P.O.A.D.P  
SANTIKOS @ BANDERA/1604

POADP # 559

# REQUEST FOR REVIEW

P.O.A.D.P REVIEW

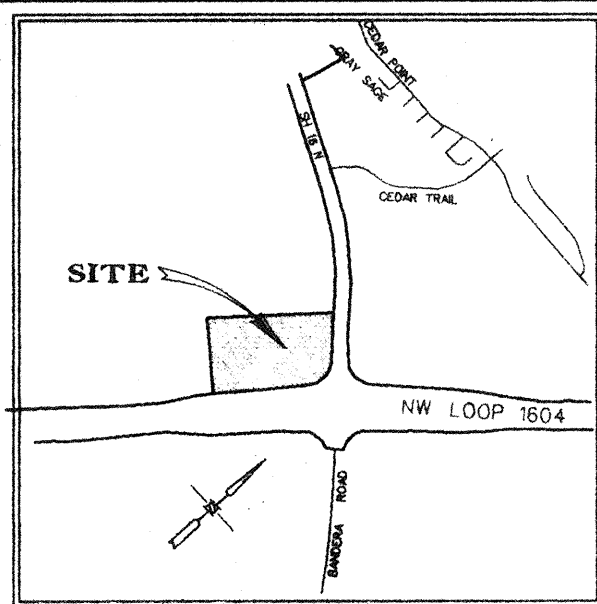
- Based on the topography, a Flood Plain Study and drainage review will probably be required during the platting process.
- Access and R.O.W. issues along State facilities will need to be resolved with the Texas Department of Transportation (TXDOT). For additional information about these requirements you can contact TXDOT at 615-5814.
- If the proposed development is not platted in phases or units this POADP will not be valid.

Comments: DRAINAGE EASEMENT MAY BE REQUIRE  
AND ADDRESS DURING THE PLATTING  
PROCESS.

Maximum of 4 access points along the overall combined SH 16 frontage of 740', and a maximum of 4 access points along the overall combined Loop 1604 frontage of 820'. Locations will be as directed by "Regulations For Access Driveways to State Highways".

Permit applications along with plans for street, driveway, utility, sidewalk and drainage construction must be submitted to the Texas Department of Transportation for review and approval before working on highway ROW. TxDOT requires that a recorded plat accompany all driveway permit applications. The Owner/Developer is responsible for preventing any adverse impact to the existing drainage system within highway ROW.

**ADDITIONAL COMMENTS:** Access restrictions were previously addressed with the platting of "Jim's at Bandera & Loop 1604" (#970153) by a letter from TxDOT dated February 26, 1997. That letter is attached for reference.
